ENVIRONMENTAL REVIEW TEAM REPORT

WINCHESTER LAKE SUBDIVISION NORFOLK AND WINCHESTER

**WINCHESTER LAKE SUBDIVISION
NORFOLK AND WINCHESTER
JUNE 1984**

FIGURE 2 SIMPLIFIED SITE PLAN

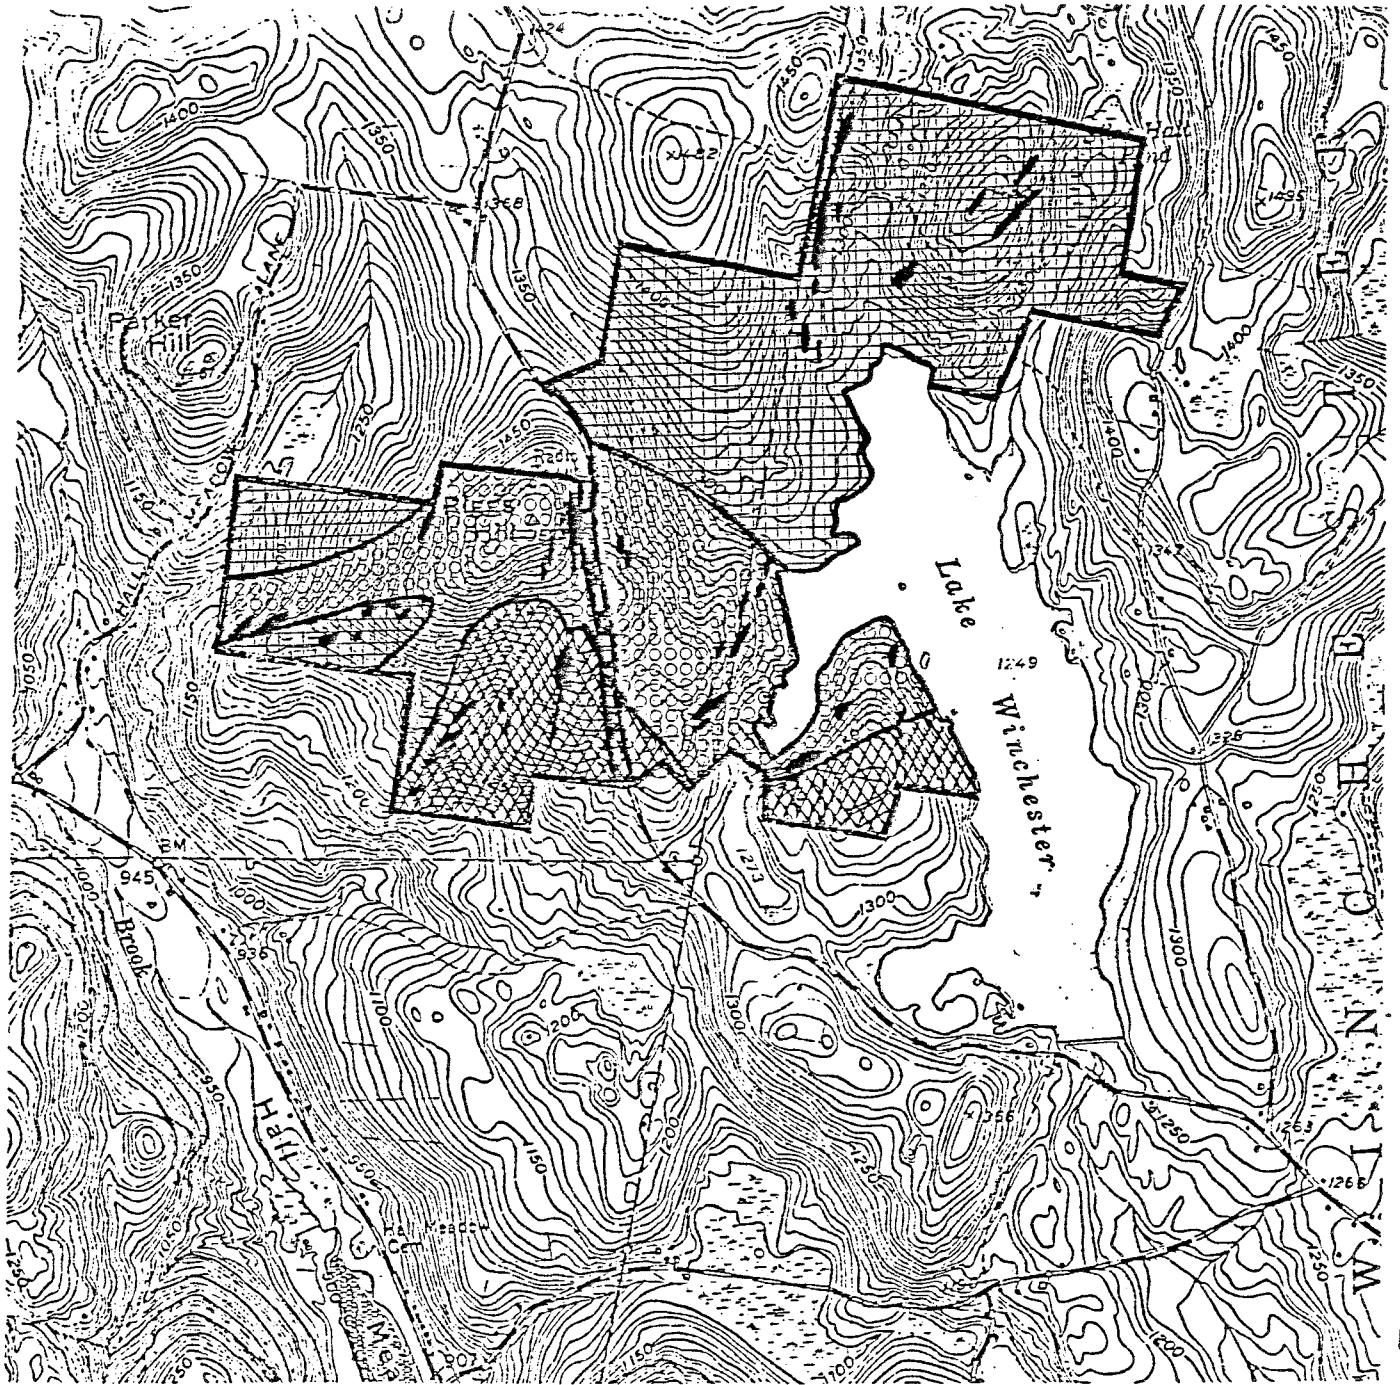
8. The proposed subdivision plan indicates that Silas Hall Pond and a ± 150 foot buffer area will be dedicated to a conservation group. Due to the uniqueness of this natural area, this is an important attribute of the plan and will serve to help protect the area. With the Nature Conservancy owning the abutting land to the north, the Conservancy would seem to be a logical group to receive the dedication and manage the land. In the opinion of the Team's planner, however, consideration should be given to expanding the area proposed for dedication to ensure protection of the Silas Hall Pond area.— In particular, the drainage area feeding this Pond would be desirable to protect. At a minimum, consideration should be given to including the steep slopes to the west of the Pond in the Conservation area and also lots 98 and 99. (p. 24)

11. The long cul~~de~~ sacs proposed under this project are inconsistent with the town's requirements and represent a safety hazard. Consideration should be given to re-designing the interior road network to mitigate this concern. (p. 29)

Even though no homes are proposed on these steep slopes and/or shallow to bedrock areas, some sections of roads and drives are proposed on slopes exceeding 10%. Alternate road locations with less steep grades, although desirable, could lead to more interior roads and more lots of smaller sizes than is currently proposed.

In the opinion of the Team's planner, consideration should be given to expanding the area proposed for dedication to ensure protection of the Silas Hall Pond area. In particular, the drainage area feeding this Pond would be desirable to protect. As shown in Figure 5, about 35 acres of this site drains to Silas Hall Pond. Ideally, all of this land would be desirable to protect in order to preserve views from the Pond and also the water quality entering the Pond. At a minimum, consideration should be given to including the steep slopes to the west of the Pond in the Conservation area and also lots 98 and 99.

FIGURE 5 WATERSHED BOUNDARY MAP

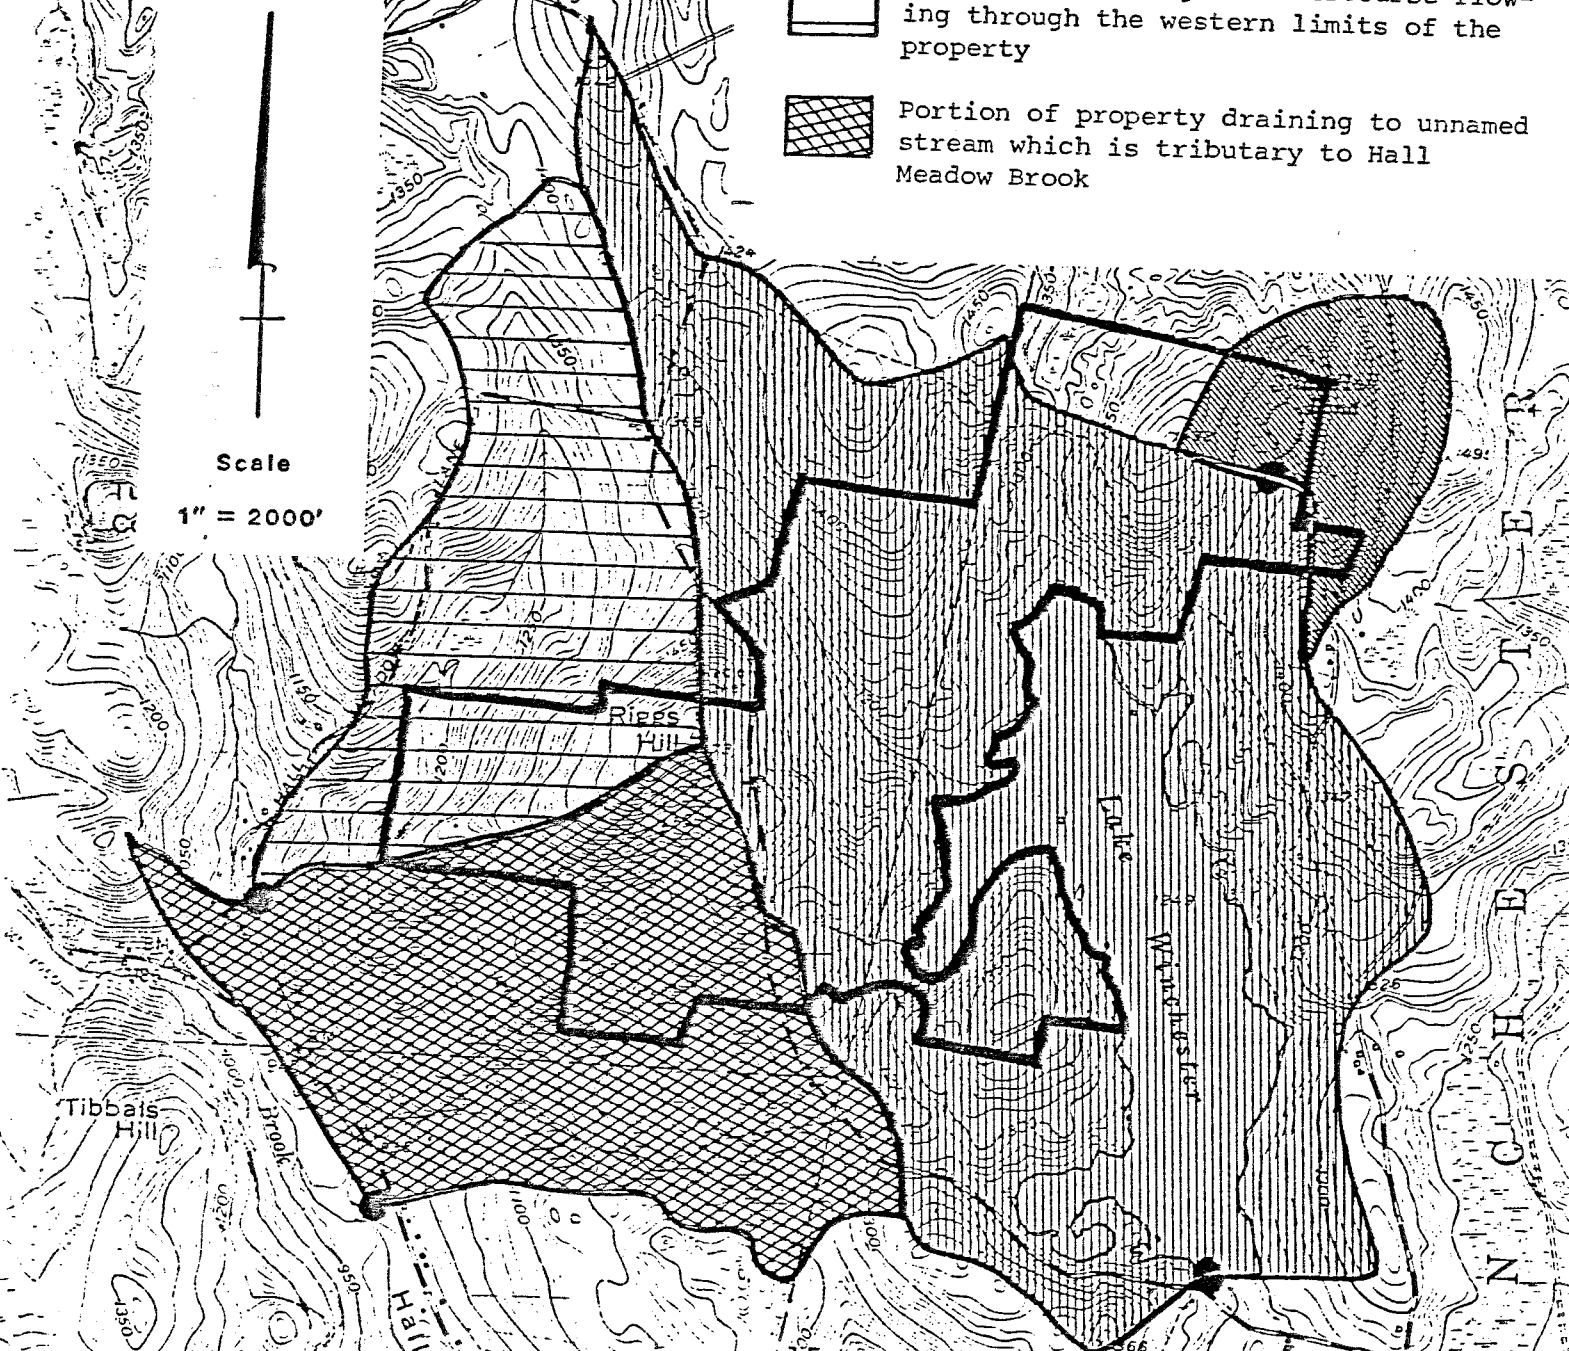
As shown in Figure 5, most of the subject site east of Winchester Road drains into Winchester Lake. At the outlet point of Winchester Lake, the watershed drains an area of approximately 1,455 acres or about 2.8 square miles.

As shown in Figure 5, a small 35 acre portion of the property in the northern limits of the site drains northerly into a wetland, which forms the headwaters for an unnamed feeder stream. This stream ultimately drains into Grant Swamp, north of the site. Surface runoff throughout the property is controlled by the underlying bedrock.

Development of the property as planned will lead to increases in the amount of surface runoff produced during periods of precipitation. These increases will arise primarily from the conversion of pervious soils to impervious surfaces (such as roofs, paved roads and driveways), compaction of soils during the construction phase, and from the removal of vegetation.

Under these conditions, it is estimated development would increase the curve number on a six acre parcel, typical of the subdivision, by 2 (from 55 to 57). During a 25 year storm event, the runoff depth would increase from 1.23 inches to 1.37 inches, an increase of about 11%. This increase should not have a significant effect on peak flows in nearby streams. However, because much of the runoff from the site takes the form of sheet flow and because of the moderate to steep slopes on the site, this increase in runoff could have a significant impact on erosion and sedimentation. For this reason, it is recommended that a detailed erosion and sediment control plan be formulated and followed prior to any development. Also, as a matter of policy, a stormwater management plan for the pre- and post-development runoff from the site should be prepared by the applicant and included with the final

subdivision proposal. Downstream culverts and/or flood prone areas should be considered in the preparation of this plan.
